RECEIPT DATE: 5/11/2023 **ONSITE SEWAGE DISPOSAL SYSTEM**

PROPERTY ADDRESS: 4890 Castlebridge Road

RE: 4890 Castlebridge
Carroll-Ziegler Property, Lot 5

SEPTIC PLAN
CARROLL-ZIEGLER PROPERTY, LOT 5
4890 CASTLEBRIDGE ROAD
ZONED: RC-DEO
TAX MAP NOS: 23 & 29 GRID NOS: 21, 22 & 3, 4 PARCEL NO: 29
THIRD ELECTION DISTRICT HOWARD COUNTY, MARYLAND
SCALE: AS SHOWN DATE: JUNE, 2018
SHEET 1 OF 1

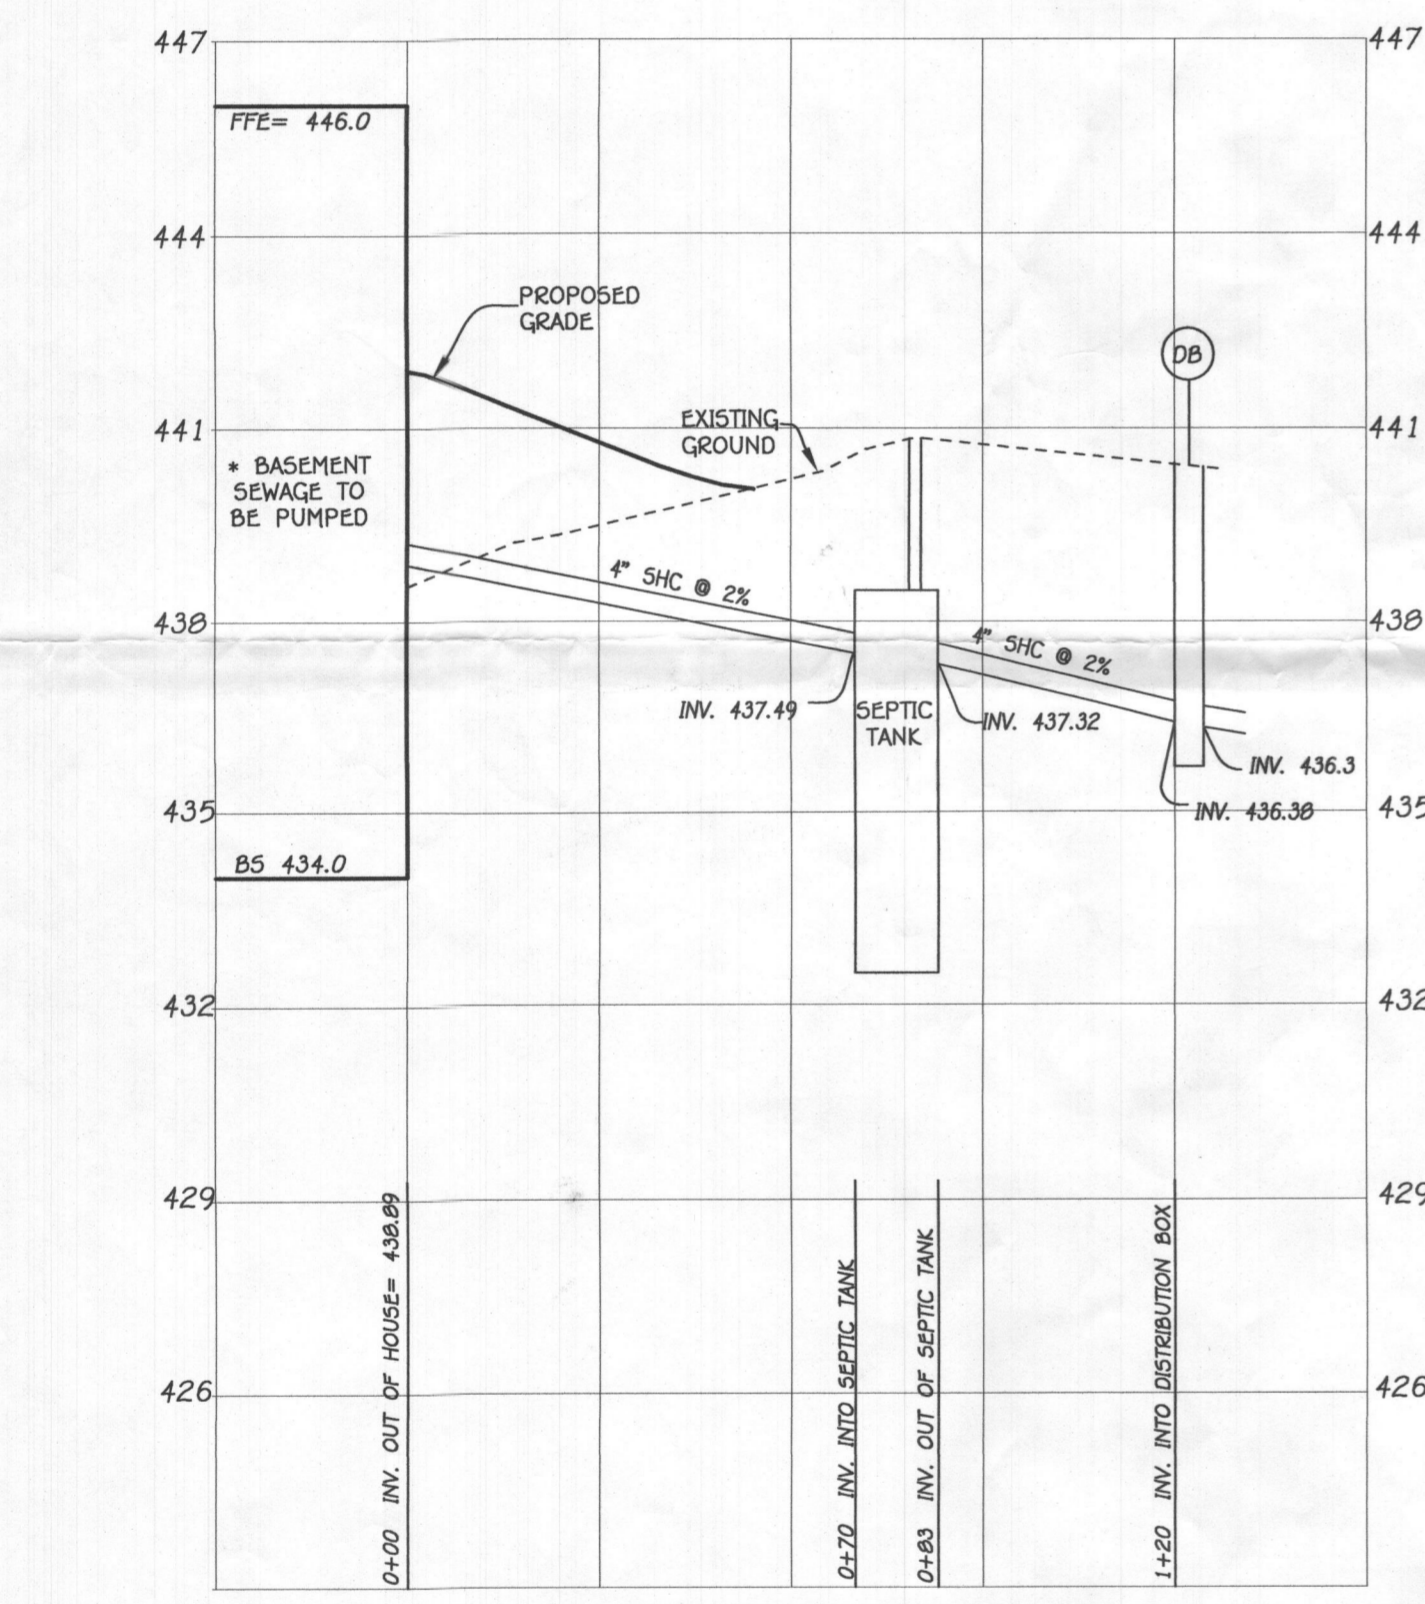
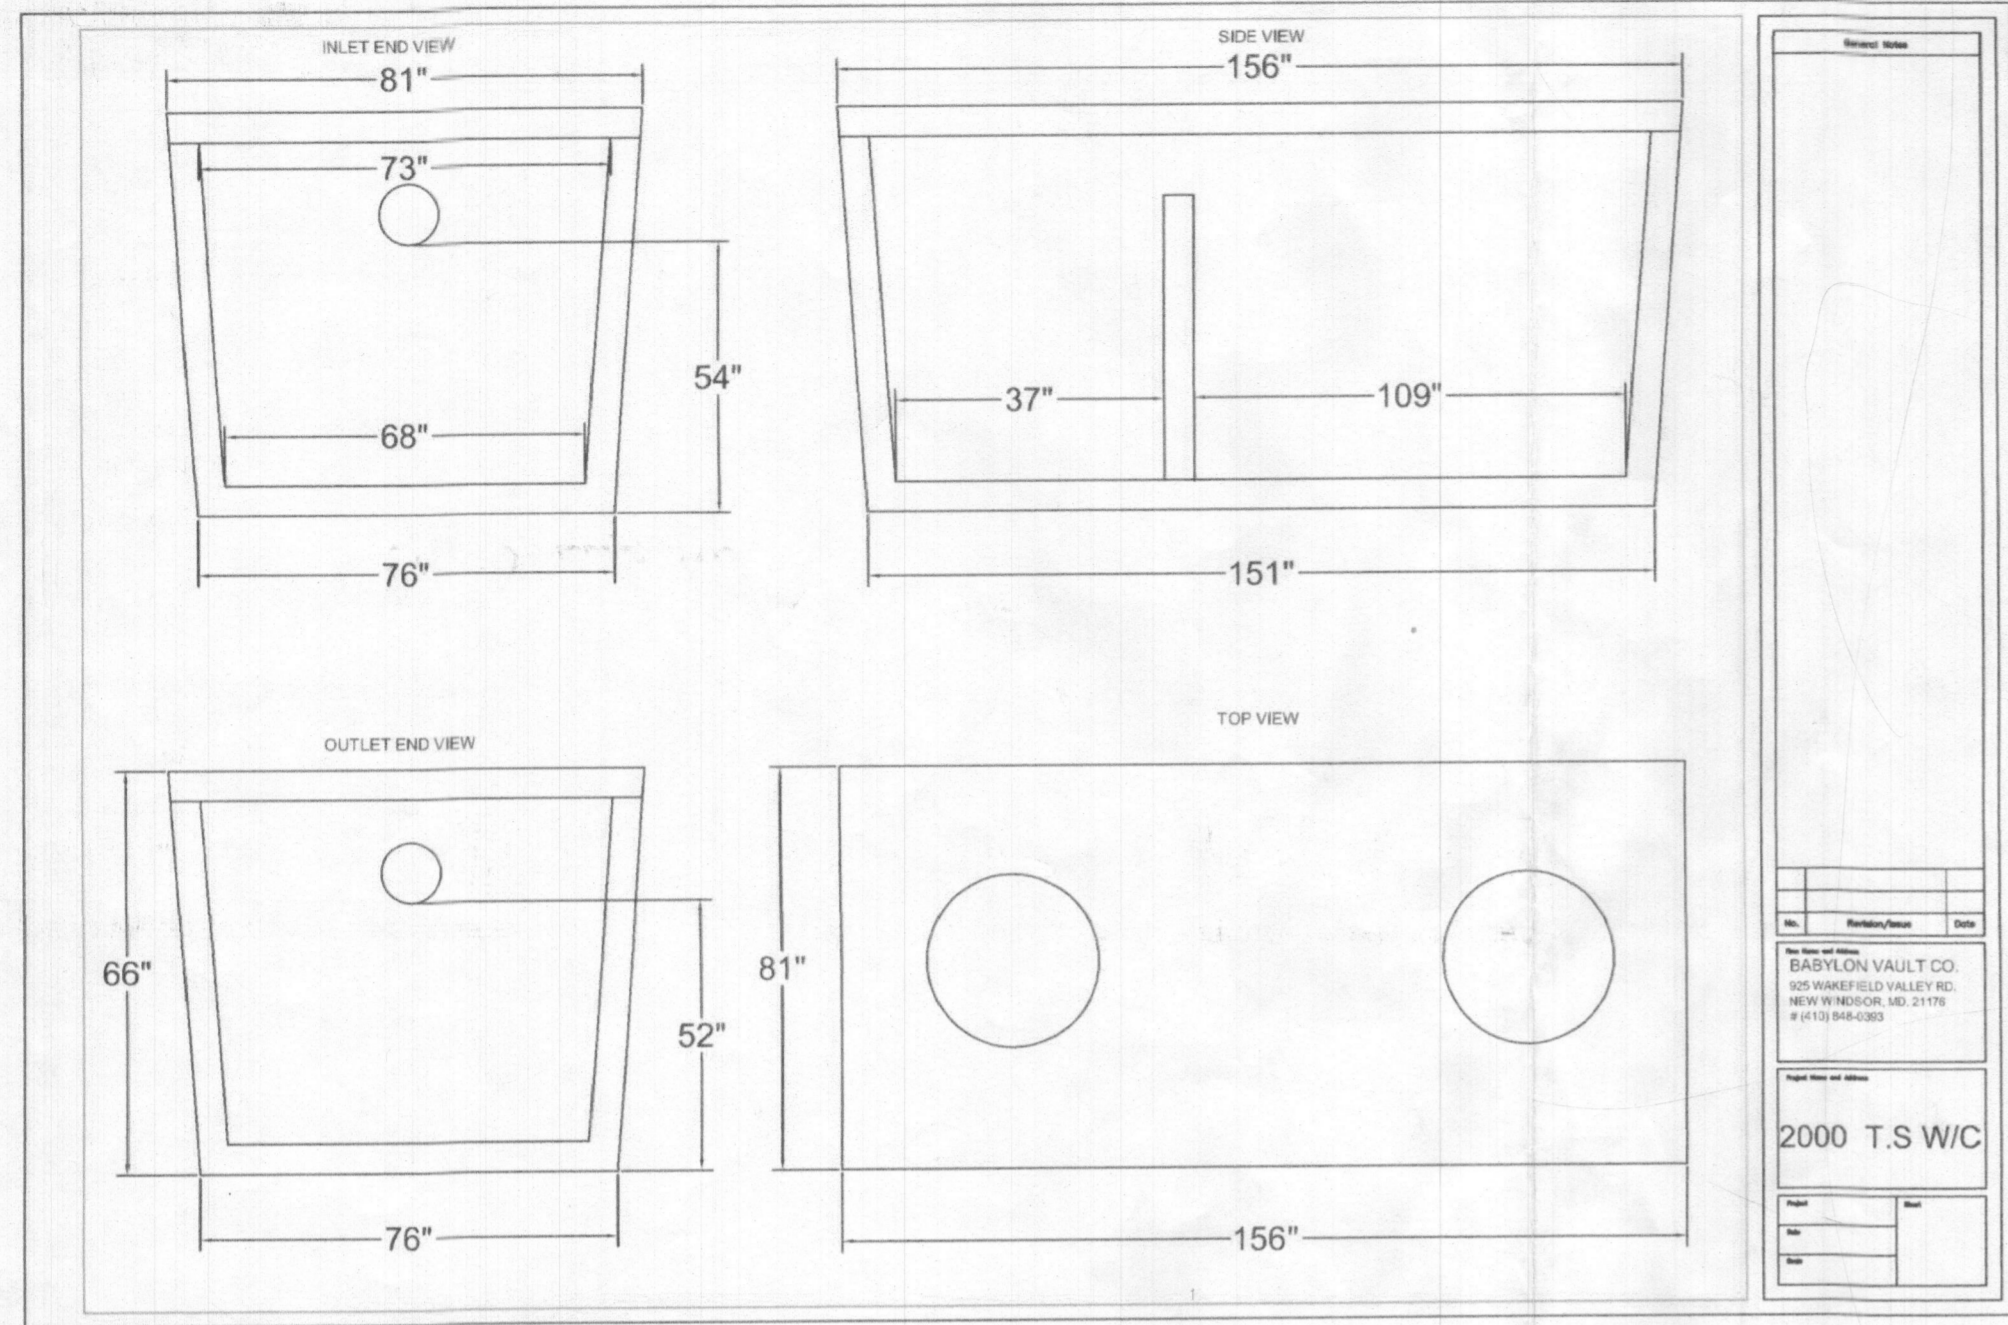
We're hesitant to do a reduced setback to a circular driveway given the increased likelihood of a car veering off and hitting the well. Can you let me know how far away you can get while staying 10' off the easement? We could maybe go less than 10' if we had a note requiring steel well casing a bollards or a big rock between the well and driveway. We didn't like the original proposal with the well right on the edge of the drive. How many feet away can you get it?

The SDA revision is fine. The well locations are not ideal with the proximity to the driveway and the decreased distance between. Does the SWM device in the rear corner need to be there? That would be an ideal place for a well box or replacement sites.

I am not sure I understand your comments. The ingress/egress is just an easement not a road/driveway, although it is for the driveway. I have moved the circular drive to provide more separation to the alternate well to give it approx. 6' to the easement and approx. 6' to the driveway, which if they ever need to drill this alternate well, bollards could be added to provide protection.

These are 32 feet apart and 3 feet off the driveway. Closest is over 58 ft from the existing well. Worst case we could add bollards, but could use something decorative in the 3 foot that would still protect the well if one is ever drilled.

Please see the attached. He had asked about alternate well locations and we are somewhat wedged in with SWM and septic. Please see if you would consider what I am proposing. We would like to show the one alternate well site approx. 32 feet from the existing well and the other another 48 feet beyond that. Hoping you will find this acceptable. There is an easement in the front of the property that we are trying to miss as well as septic and SWM. Thanks.
